Final Report
Limited Soil Investigation of Project
Chariot Test Holes
Cape Thompson, Alaska

December 2010

Fairbanks Environmental Services

FAIRBANKS ENVIRONMENTAL SERVICES 3538 INTERNATIONAL STREET FAIRBANKS, ALASKA	 ALASKA DISTRICT CORPS OF ENGINEERS ANCHORAGE, ALASKA
Project Site Map	
Limited Soil Investigation of Project Chariot Test Holes Cape Thompson, Alaska	
CONTRACT: W911KB-08-D-0003	FIGURE: 2
DATE: 12/10

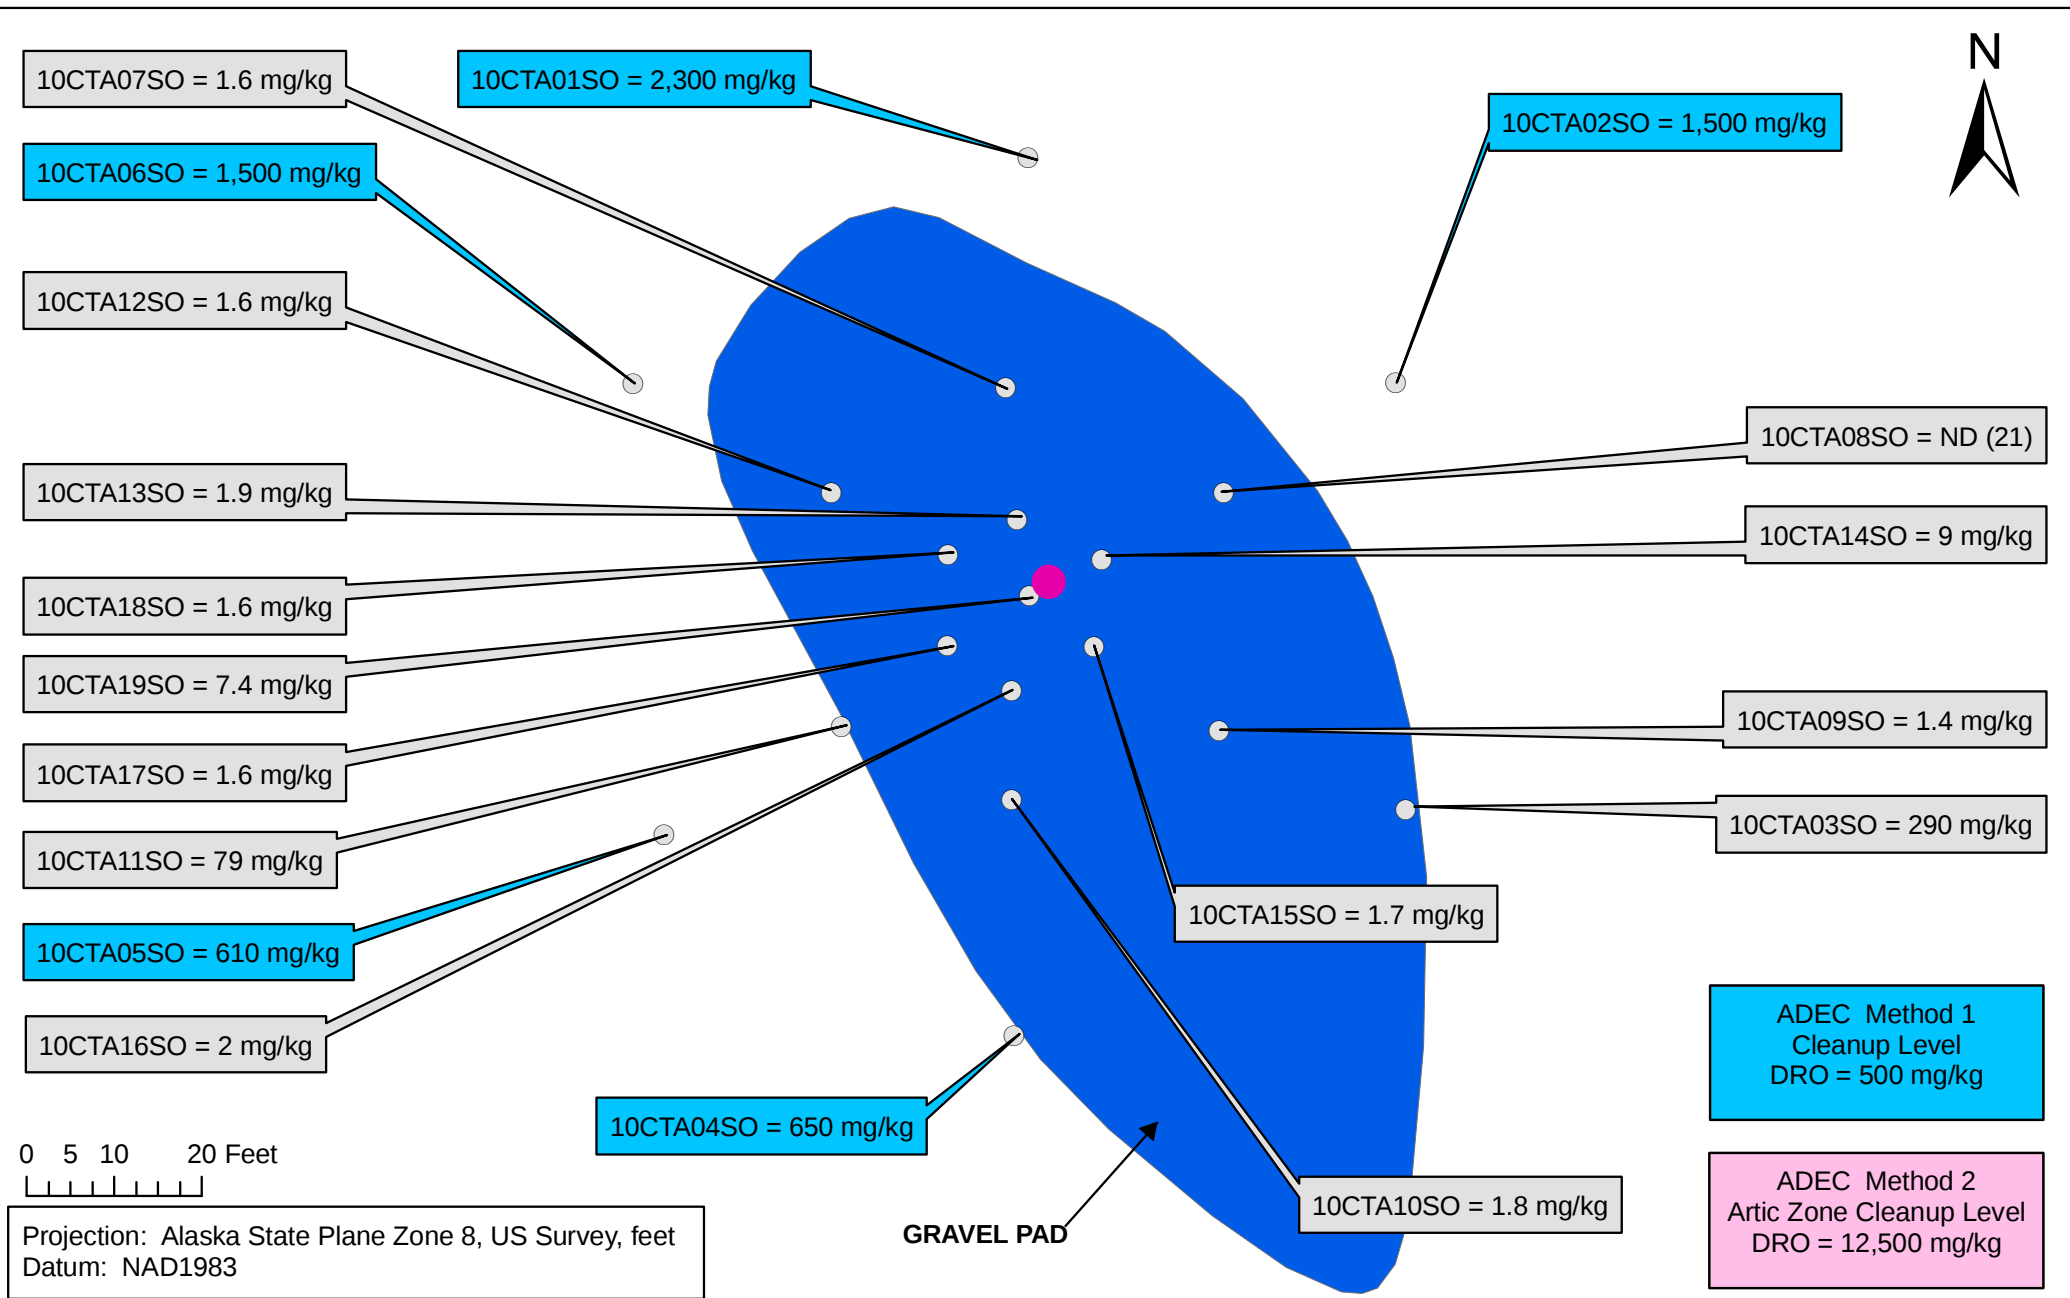
| 1 | Figures         | Figure 2 did not provide the XREF.                                                                                                                                                                                                                                                                  | A – XREF will be provided with the final submittal.                                                                                                                                                                                                                                                                                                                                                                               |  |  |
